**Chemung County Stormwater
Construction Inspection
Erosion and Sediment Control**

Project Name CDS Monarch Senior Living Facility	Date 6-26-18
Location Maple Ave. City of Elmira	Permit # NYR11C547
Weather Conditions Sunny, warm	Entry Time: 10:10
On-Site Representative Present: Jeff & Justin Bellinger, Christa	Exit Time: 10:28

PROJECT: CDS Monarch Senior Living
City of Elmira
Municipal Construction Inspection
June 26, 2018

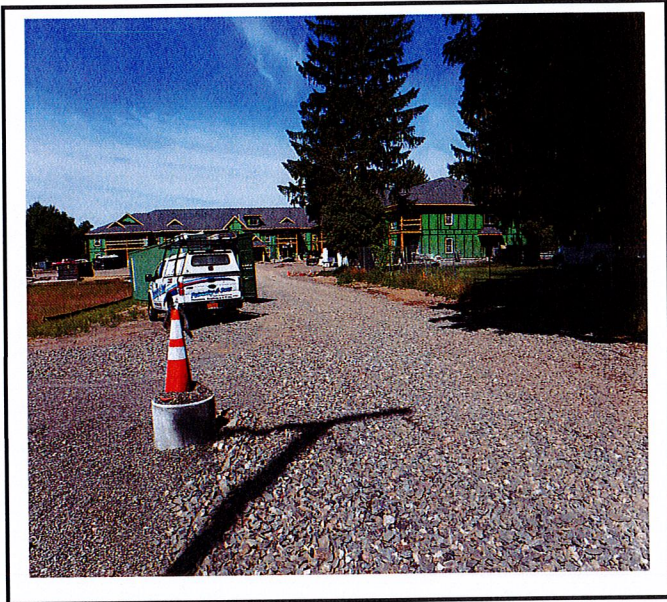
Water is getting under compost sock. Rock has been placed in eroded area but water is still cutting around it.
